**From:** [Andrea Wamsley](#)  
**To:** [Al Royse](#); [Christine Krolik](#); [Marie Chuang](#); [Sophie Cole](#); [Larry May](#); [Lisa Natusch](#); [Ann Ritzma](#)  
**Subject:** Comments for Crown Castle Wireless Application Town Meeting June 3, 2021  
**Date:** Thursday, June 3, 2021 1:29:11 PM

## **Please enter the comments below to the Public Record for the Thursday June 3, 2021 Town Meeting Regarding the Wireless Cell Towers**

**From:** Josh B [REDACTED]  
**Sent:** Thursday, June 3, 2021 3:03 PM  
**To:** Wireless Comments  
**Cc:** Al Royse; Christine Krolik; Larry May; Marie Chuang; Sophie Cole; Ann Ritzma; Paul Willis; Lisa Natusch  
**Subject:** 157 violations is acceptable?

### **H21M3 / 660 El Cerrito**

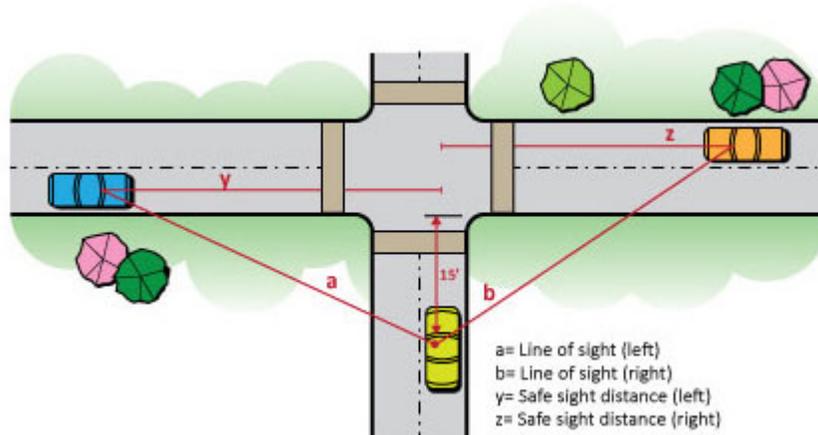
C3 requires “applicants that propose to install a WCF on a new, non-replacement pole must install a support structure that fully conceals the equipment from public view and blends with the surrounding environment.” H21M3 does not comply, as it does not “[blend] with the surrounding environment,” as the stark green monopole is offset so far from thin/sparse surrounding vegetation such that it stands out visually due to both its color and location.

C3 requires that “if there are no existing streetlights in the immediate vicinity, the applicant may install a metal or composite decorative pole capable of concealing all the accessory equipment either within the pole or within an enclosure integrated into the base of the pole,” however H21M3 does not comply as it includes a ground pedestal meter mounted outside of the pole structure.

C3 requires that “pole height shall not exceed 32 feet in overall height above ground level adjacent to the base of the pole,” therefore H21M3 does not comply since the entire pole structure is 35’ high.

C3 requires that the “pole diameter shall not exceed 18 inches,” therefore H21M3 does not comply since the bottom of the pole structure is 35.75”.

C3 requires that the “any base enclosure [of the pole structure] shall not exceed 24 inches,” therefore H21M3 does not comply since the base of the pole structure is 35.75”.

C5 requires that “equipment placed above ground, whether pole-mounted or ground-mounted , shall be placed so as to avoid, to the extent technically feasible, prominent visibility from the driveways, entryways and windows associated with residential dwellings.” As the applicant did not provide any tangible evidence that it would be technically infeasible to place H21M3 in a location where it does not have “prominent visibility from the driveways, entryways and windows associated with residential dwellings,” H21M3 does not comply since it is prominently visible from the driveway, windows and entryways of 660 El Cerrito, as well as other residential dwellings.

E2 requires that for “a WCF or other infrastructure deployment located in the public rights-of-way,” “with respect to its pole-mounted components, be located on an existing or replacement streetlight or an existing utility pole serving another utility; provided, however, that if no streetlight or utility pole exists within 500 feet from the proposed site location,” “the applicant may propose a new, non-replacement pole consistent with the provisions in Section C.” Since there is a utility pole ~75’ from the proposed site near 660 El Cerrito where the antenna and other pole-mounted components for H21M3 could be mounted, H21M3 does not comply with E2.

E6 requires that “a WCF or other infrastructure deployment located in the public rights-of-way” “shall not be permitted with any individual antenna that exceeds three cubic feet in volume” and that “the volume calculation shall include the antenna, any radios physically integrated with the antenna, any mounting hardware and any shroud or radome.” H21M3 does not comply, as the canister antenna alone is 4.7 cubic feet in volume.

E7 requires that for “a WCF or other infrastructure deployment located in the public rights-of-way,” “all accessory equipment installed above ground level shall not cumulatively exceed...nine cubic feet in volume if installed in a residential district” and that “the volume calculation shall include any shroud, cabinet or other concealment device used in connection with the accessory equipment.” Based on the May 2021 report for the Town of Hillsborough by Columbia Telecommunications Corporation (CTC), which notes that the “accompanying equipment cabinet exceeds 31 cubic feet” on its own, H21M3 does not comply, as the cumulative volume is more than 300% the allowed limit.
